Plan Change 17

Te Rapa North Industrial Private Plan

Addendum Section 42A Hearing

27 November 2025

*Figure 1: Properties covered by Deferred Industrial Zone Overlay
in vicinity of Meadowview Lane submitters*

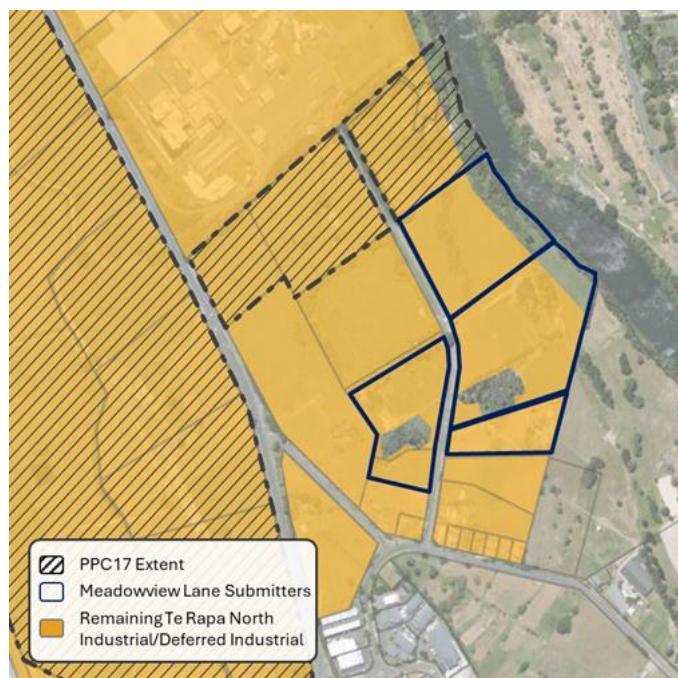
4.11 I note that the Meadowview submitters represent approximately half of the area shown in Figure 1 above, and it is unknown what the position of other landowners within this broader block is at this point. While some of these property owners did initially submit on PPC17 (e.g. Morth Trust, submitter 16), I note that no further evidence has been produced by these parties that suggests inclusion within PPC17 is still being pursued.

4.12 Based on the above, I consider that PPC17 in its current form will not lead to the outcomes suggested by Ms Belgrave. In my opinion, the surrounding land holdings, including adjacent blocks within the Deferred Industrial Overlay (owned by others), could be comprehensively planned for given their size and location relative to the Fonterra South block, should landowners wish to pursue a plan change. Inclusion of the Meadowview submitter properties only within PPC17 without the inclusion of other surrounding blocks would in my view result in an incoherent zoning pattern.

4.13 In addition, and as Mr Grala notes, no technical assessment has been undertaken for this wider land grouping. I agree that various assessments would be essential to properly address the site's context and constraints and to inform any future plan change provisions.
